Access Compliance Report

Public Rights-of-Way

(Curb Ramps)

Intersection ID: 5124	Main Street: GIBBON_RD	Cross Street: OLD_STATESVILLE_RD	Location: W
ADA ID: 03B09706099F	Ramp Type: Perp	Initial Pass/Fail: Fail	Overall Compliance: No
Severity Score: 33.75			
Codes/Mitigation Info/Possible Solution		Field Measurements/Component Compliance

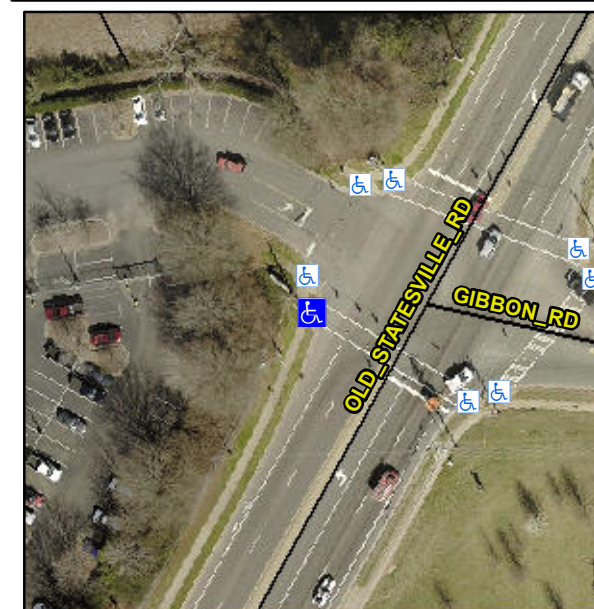
Not Found, R304.5.1, R304.2.2

Compliance	Description	Data	Compliance	Description	Data
N/A	Ramp Length (in)	45.0	No	Ramp Slope (%)	13.8
No	Ramp Width (in)	43.0	Yes	Ramp XSlope (%)	1.7
N/A	Flare Type LT	N/A	N/A	Flare Type RT	N/A
N/A	Flare Slope LT (%)	N/A	N/A	Flare Slope RT (%)	N/A
N/A	Flare Traversable LT?	N/A	N/A	Flare Traversable RT?	N/A
N/A	Landing Length (in)	N/A	N/A	DWS Provided?	N/A
N/A	Landing Width (in)	N/A	N/A	DWS Contrast?	N/A
N/A	Landing Slope (%)	N/A	N/A	DWS Length (in)	N/A
N/A	Landing X Slope (%)	N/A	N/A	DWS Full Width?	N/A
N/A	Landing Curb? (Y/N)	N/A	N/A	DWS Offset (in)	N/A
N/A	Shared Landing?	N/A			
N/A	Gutter Ponding?	N/A	N/A	Gutter Slope (%)	N/A
N/A	Gutter Lip Ht (in)	N/A	N/A	Gutter X Slope (%)	N/A
N/A	Painted X Walk1?	Yes	N/A	Painted X Walk2?	N/A
	X Walk 1 Direction	To S		X Walk 2 Direction	N/A
N/A	X Walk 1 Width (in)	113.0	N/A	X Walk 2 Width (in)	N/A
	X Walk 1 Slope (%)	0.7		X Walk 2 Slope (%)	N/A
	X Walk 1 X Slope (%)	1.1		X Walk 2 X Slope (%)	N/A

Remove & Replace Entire Ramp.
